Intel[®] Communications Chipset 8900 Series

Specification Update

June 2016

Figure 2. 1000BASE-BX/FC-PI Transmitter Electrical Specifications

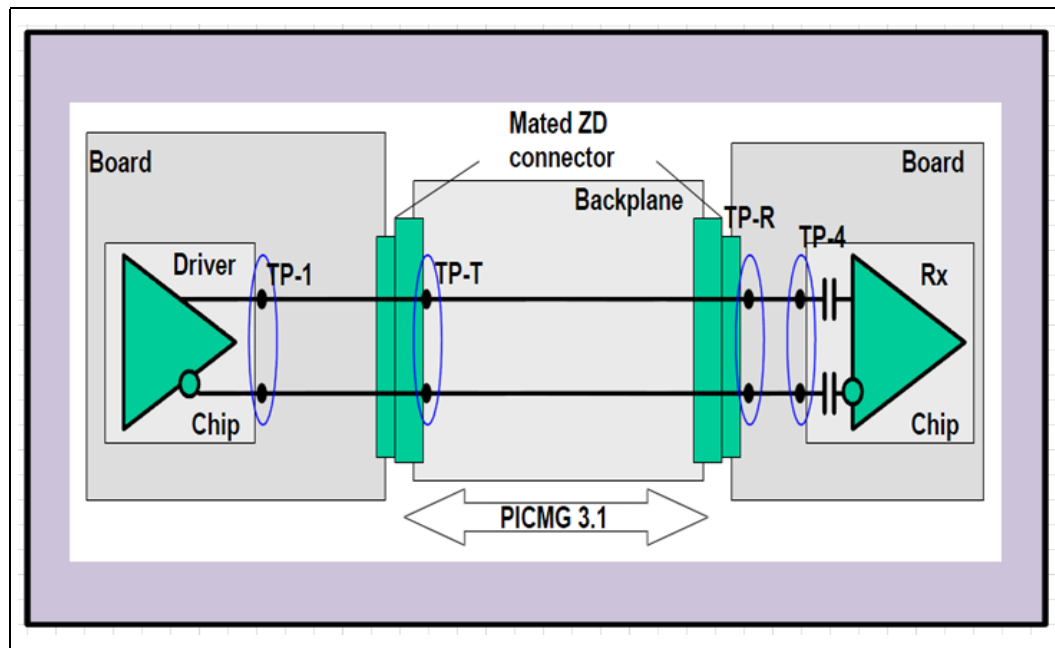
Implication: Although this is a specification violation, it does not affect the functional operation of the interface.

Workaround: Ensure that the signal routing length from TP-1 to TP-4 is greater than 10". Refer to *Intel® Communications Chipset 8900 Series Platform Design Guide (PDG)* for maximum routing length. (See Figure 2.)
